Date: May 17, 2021

Subject: Superior Air Parts through-bolt part number SA641931-9.81 replacement

Illustration 1

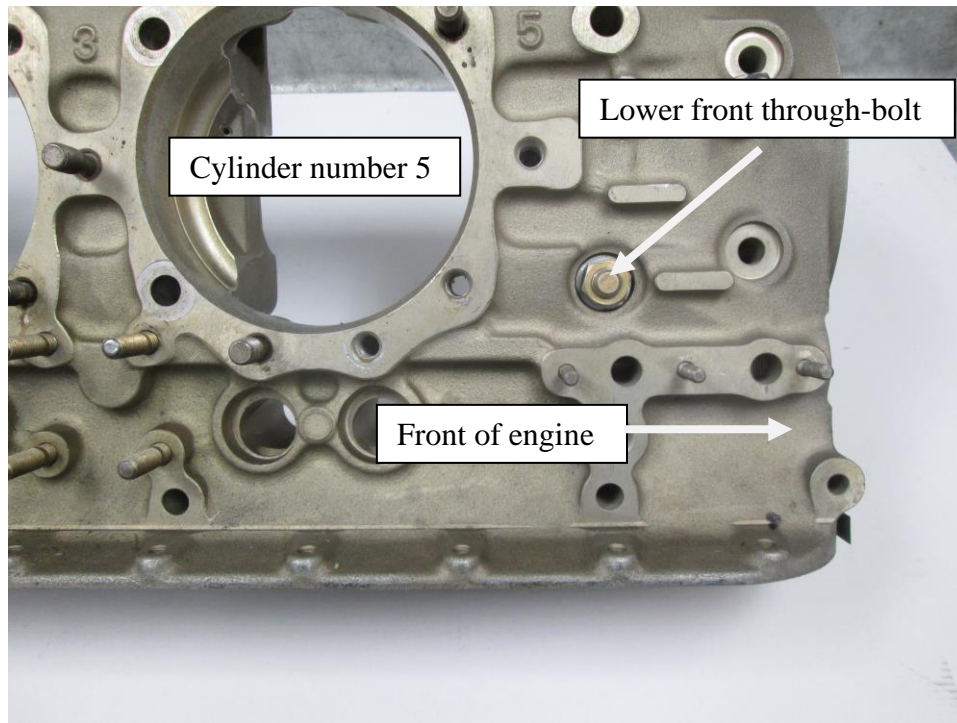
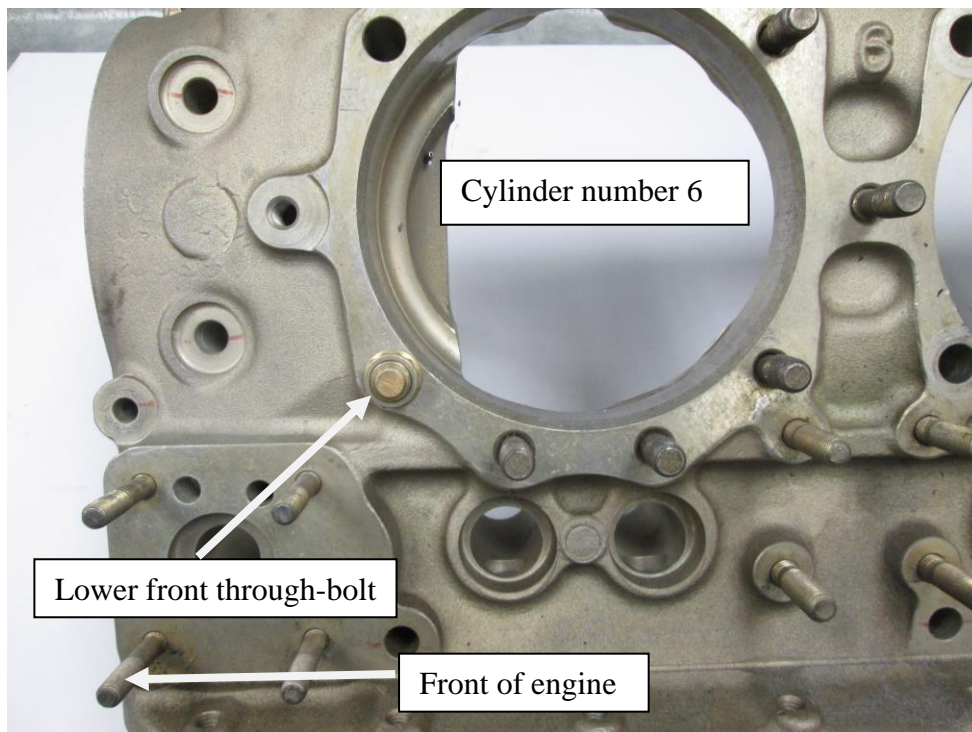
- 2) Remove the lower front through-bolt in accordance with the Continental Motors Inc. maintenance or maintenance and overhaul manual. See illustration number 1 and 2

Within the next 10 hours, the lower front through-bolt, part number SA641931-9.81, should be removed and replaced with part number 641931-9.81. Through-bolt replacement kits will be supplied by Superior Air Parts Kit number ("SB THRUBOLT KIT"). Each kit will contain the following parts for compliance with this Service Bulletin:

Illustration 3

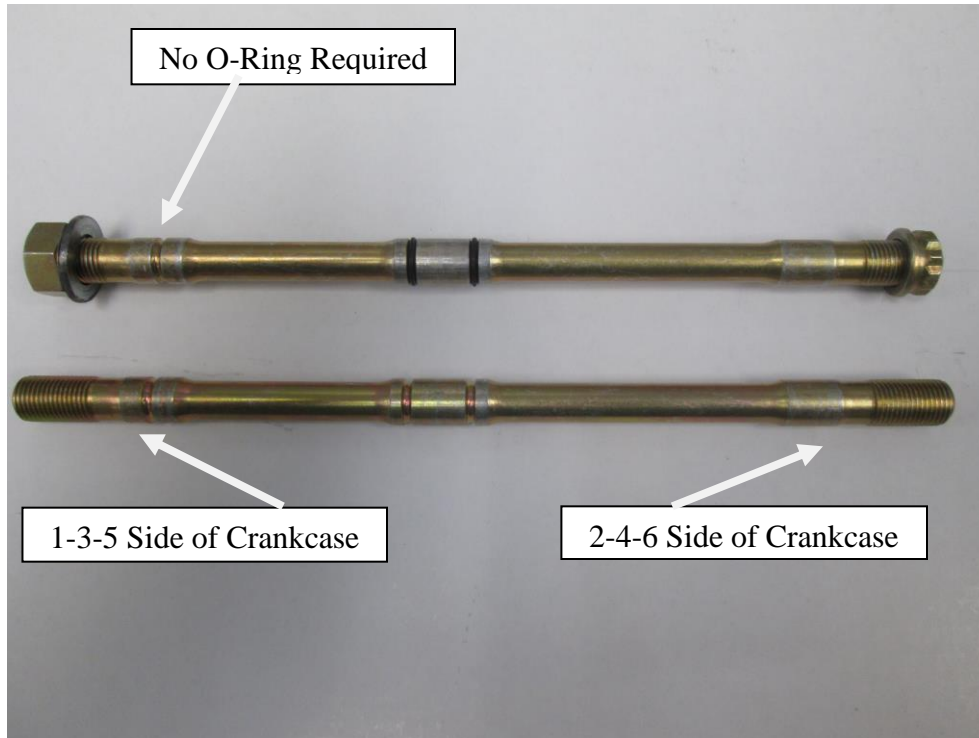
- 3) Without installing the included O-rings, slide the new through bolt into position in the crankcase. See Illustration 3 for correct orientation. There should be only slight resistance sliding through the crankcase and may require light tapping with a rubber mallet to move through-bolt into position. If the through-bolt will not slide through the case and into position, please contact Superior Air Parts.

- 4) If the bolt settles into position, remove and install the O-rings on the center section of the bolt. The groove closest to the oil cooler side does not require O-rings. Install the bolt and torque fasteners to proper specifications as set forth in the latest revision of Continental Motors Inc. Maintenance or Maintenance and Overhaul Manual and Continental Motors Inc. M-0. Note the 6 point nut and the 12 point nuts may have different torque values. There is no need to repeat an entire torque sequence for all cylinder fasteners but only the through bolt and its respective fasteners being replaced.
